**Campaign for the Protection of Rural
Wales
Brecon and Radnor Branch
Upper Noyadd, Clyro, HR3 5JS
01497 820814**

HENDY WIND FARM: Land Off A44 SW Of Llandegley Llandrindod Wells Powys

Application for discharge of condition 40 from P/2014/0672 (APP/T6850/A/17/3176128):HMEP

Hendy Windfarm Development Hydrological Impacts

Figure 5. The 20m (yellow) and 50m (pink) buffer around waterways (blue) in the area of the wind turbine development site (red outline). Background map OS 1:10,000 open raster.

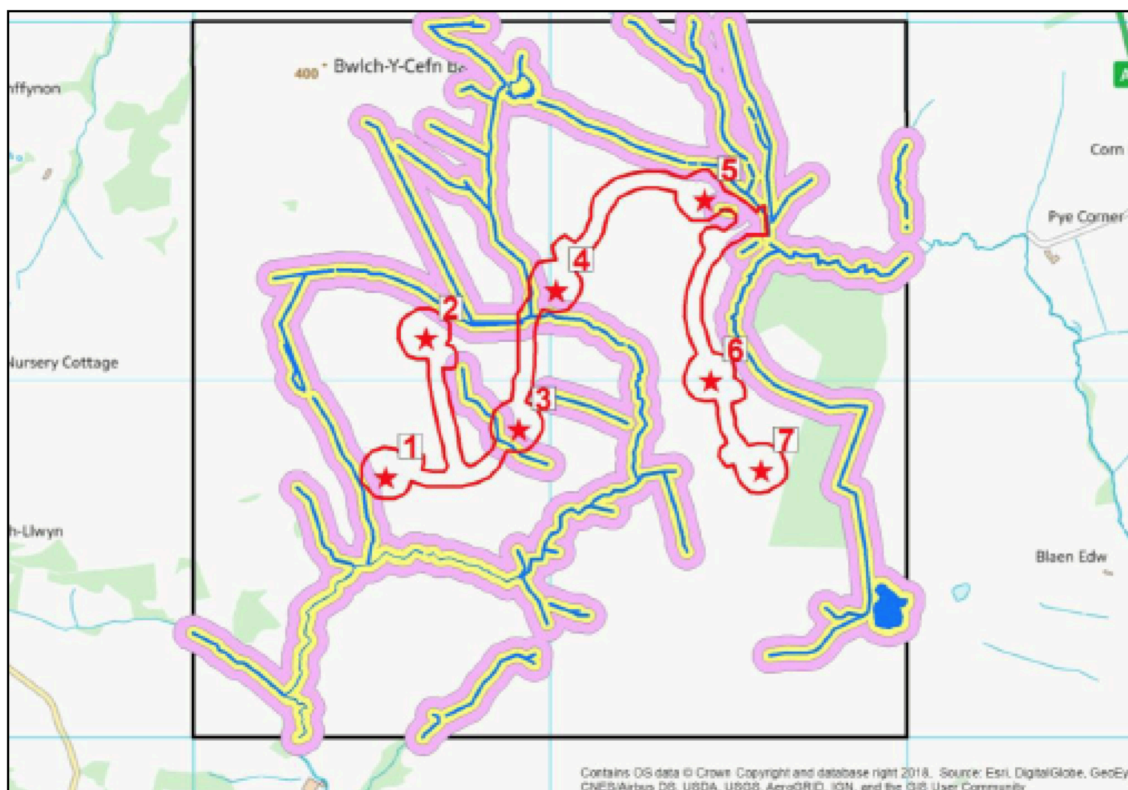
“keep 20m from watercourses where possible”, “keep turbine bases 20m from watercourses”

- At this stage of discharging pre-commencement conditions there should be site-specific measures for the construction management of all areas where the plans impinge on watercourses (see Hydrology Report Appx 1)

Figure 1. The wind turbine locations shown in red, background map OS 1:25,000 sheet 200.

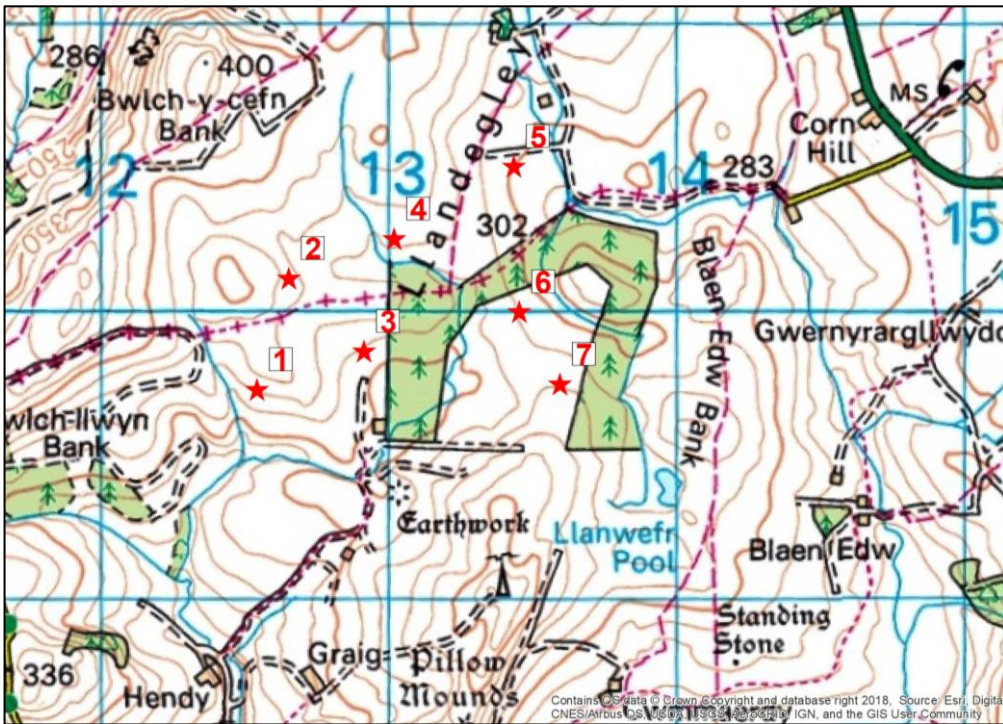
The location of the seven turbine sites are shown in Figure 1. A visit to the site on 11th January 2019 confirmed that the development is an upland area of steep to rolling topography with rough grazing, moorland and forestry, as shown in Figure 2. The area includes the upper reaches of the River Edw (Figure 3) and the Nant Brook - both tributaries of the River Wye which has been designated as a Special Area of Conservation. The visit also confirmed that work had begun on Turbine number 5, the most northerly of the sites which was viewed from the byway open to all traffic in Figure 4. This shows the extent of excavations at the site and the amount of bare soil which has been uncovered.

A proper consideration of mitigation features also needs to be included. It appears that much of the text describing mitigation in the SWMP is simply generic, and in many cases does not consider if these are appropriate for the type of the development and the setting within the landscape. For example, the use of swales is proposed for turbine bases, tracks, compound, sub-station and crane pad construction mitigation. Swales are described in detail in the current SUDS guidelines and are shallow ditches with a 1 in 4 side-slope which are included in designs not to convey water but to collect water from impermeable surfaces and allow the gradual infiltration into the soil/groundwater or loss through evapotranspiration. The swales are described as having a maximum depth of water as 0.3m. To comply with the 1 in 4 side slope each side of the swale would need to cover a distance of 1.2m. Assuming a base of 1m, the total width would need to be 3.4m. The excavation of a swale along side the type of access tracks in the steep to rolling topography of the wind turbine site, such as that shown in Figure 1, would not be possible.

Figure 5. The 20m (yellow) and 50m (pink) buffer around waterways (blue) in the area of the wind turbine development site (red outline). Background map OS 1:10,000 open raster.

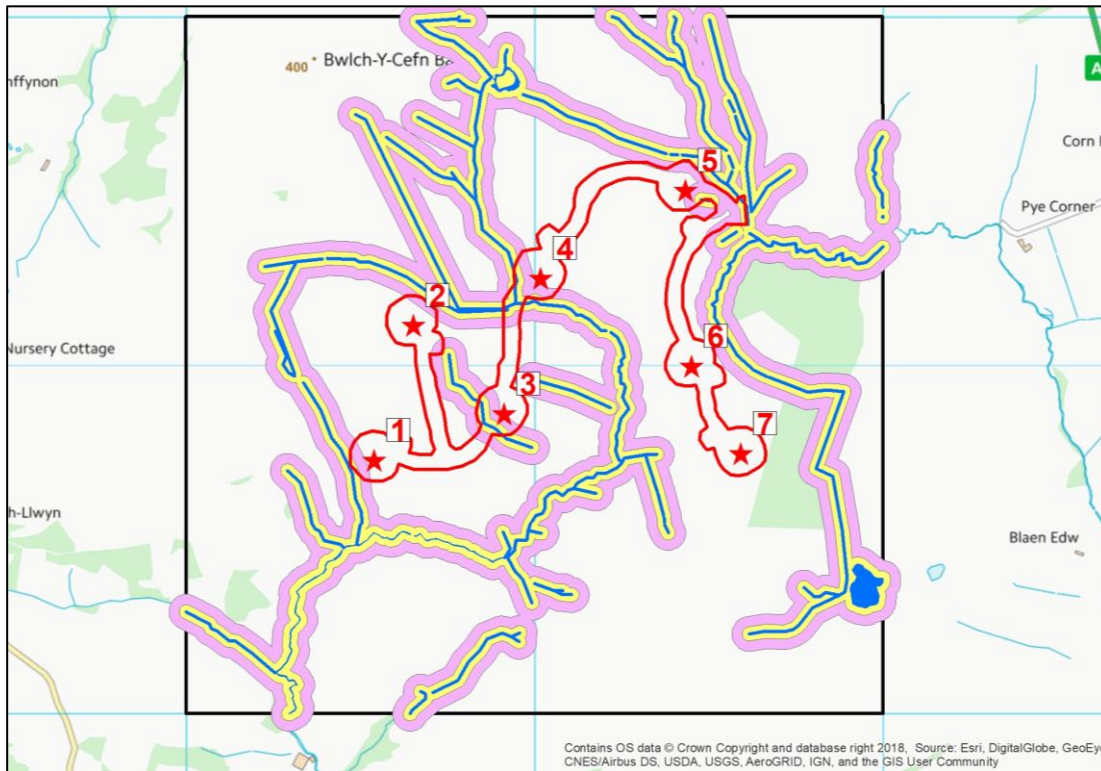
Other methods such as the use of GIS to produce maps and perform spatial analysis should have been demonstrated. For example, a common mitigation method mentioned throughout the SWMP (and ES) is the limiting of any construction work where possible to areas outside buffer from each waterway. The ES used a 20m buffer but the SWMP suggested a 50m buffer. Neither report provided any maps indicating the extent of these buffers in relation to the development area. Such mapping is a relatively straightforward exercise using GIS software. An example of these buffers for the 4km area surrounding the development site is shown in Figure 5.
